## SERVICE LETTER 209

### Fire Boss AT-802 (Two Seater) Removal of Fixed Ballast

<b>Aircraft Makes/Model(s):</b>	<b>Float Model(s):</b>	<b>Compliance:</b> Optional	<b>By:</b> MAS
Air Tractor AT-802 Only (Two Seater)	10000A	<b>Part Number:</b> 1011926	<b>Approved:</b> DRH
		<b>Date:</b> Pending	<b>Revision:</b> B

Figure 1

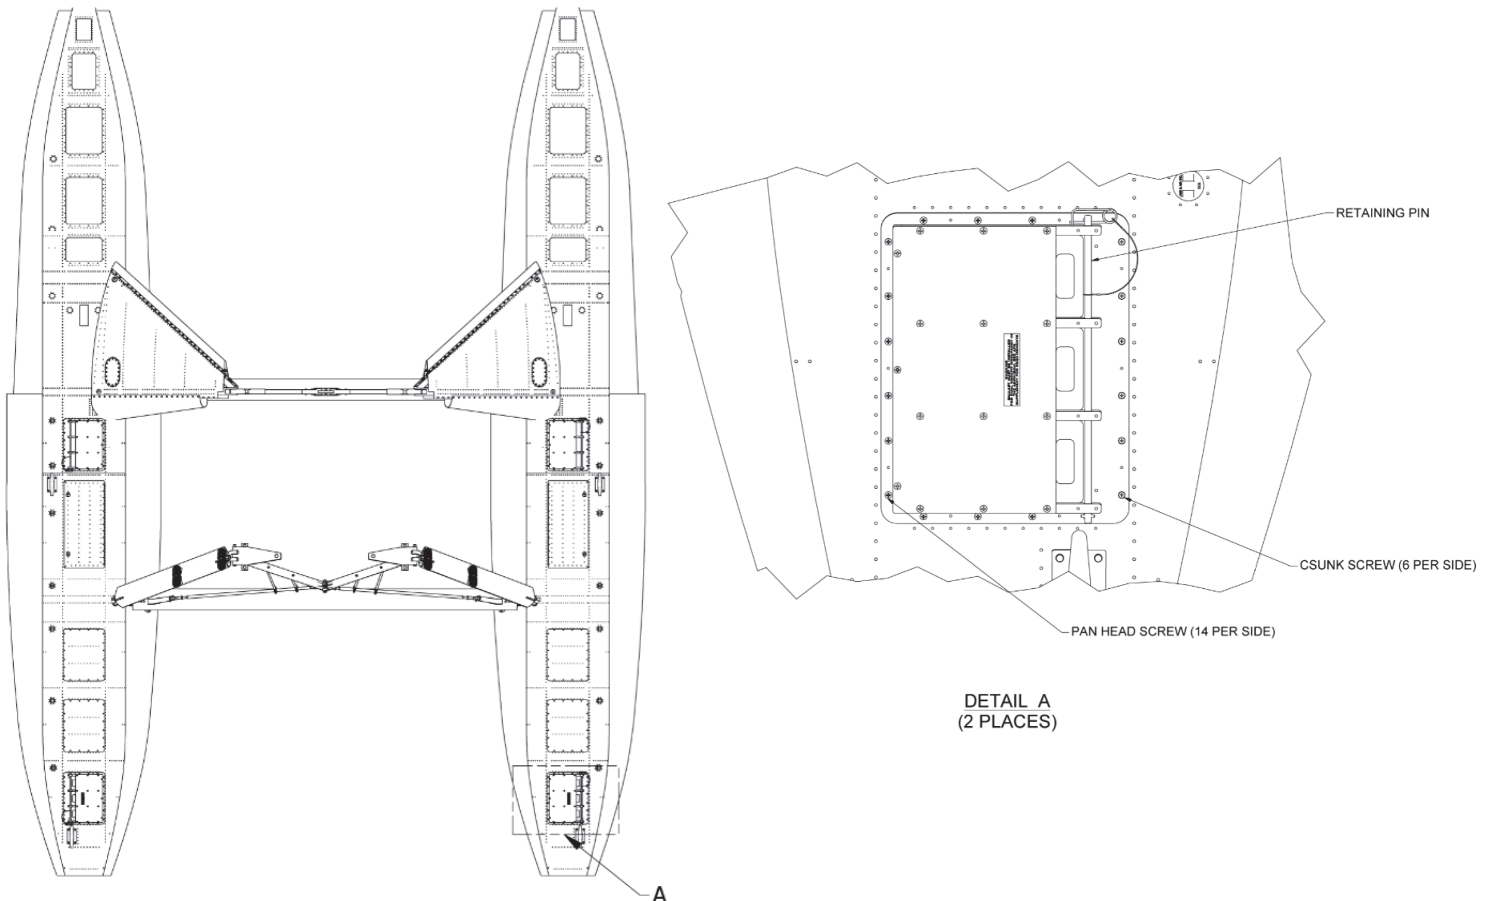
1. Temporarily remove forward ballast assemblies from floats by removing (14) pan head screws and (6) countersunk screws per float. Remove retaining pin as needed to access screw heads. Reference Figure 1.
2. Remove the fixed ballast plates from bottom of assembly by removing (16) AN3 bolts. Reference Figure 2.
3. Either:
  - a. Re-fasten the thicker ballast plates using red Loctite (or equivalent) and hardware shown in Table 1. The longer bolts are used closest to the center, screwing into the two ribs which form the bay for the center removable ballast plate.
  - b. Remove both the thick and thin ballast plates from aircraft. New hardware not required.
4. Reinstall both forward ballast assemblies using (14) pan head screws and (6) countersunk screws per float. Reinstall retaining pin, if removed.

**Figure 2**

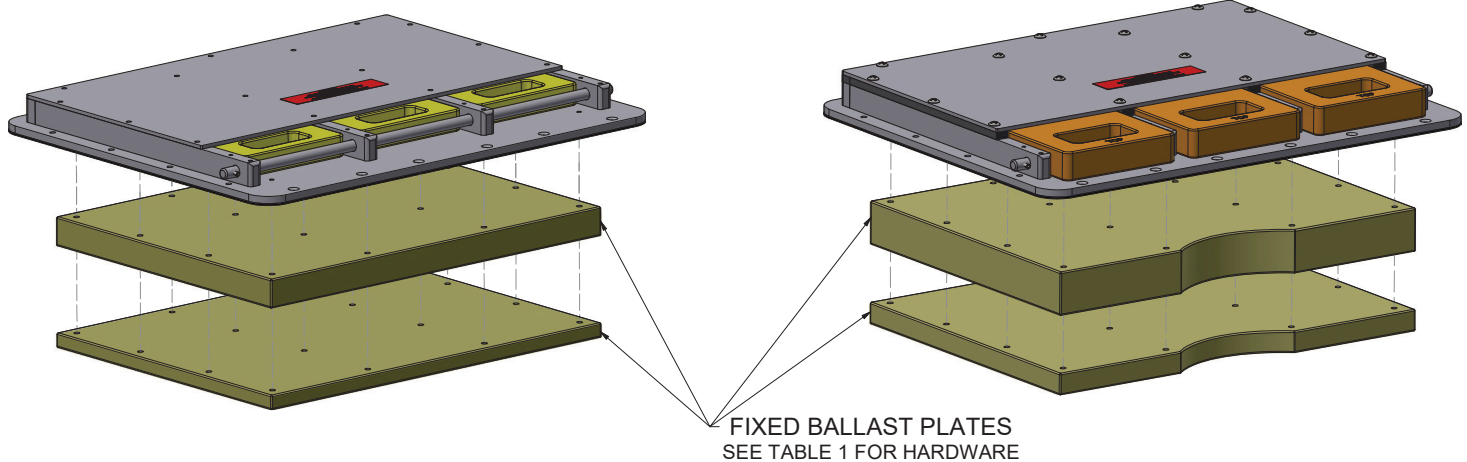
Revision	Description	Date
A	Initial release	7/1/2021
B	Updated Work Instructions, Table 1, and Figure 2 to address steel ballast plates.	12/9/2024

Configuration	Weight change	Arm*	Hardware
Original (both plates)	-	-	Lead: (8) AN3-16A, (8) AN3-21A Steel: (8)AN3-24A, (8)AN3-27A
Remove thinner plate Lead: 1/2" thick Steel: 3/4" thick	-65.4 lbs (32.7 lbs per float)	-92 inches	Lead: (8) AN3-12A, (8) AN3-15A Steel: (8)AN3-16A, (8)AN3-21A
Remove both plates	-196 lbs (98 lbs per float)	-92 inches	None
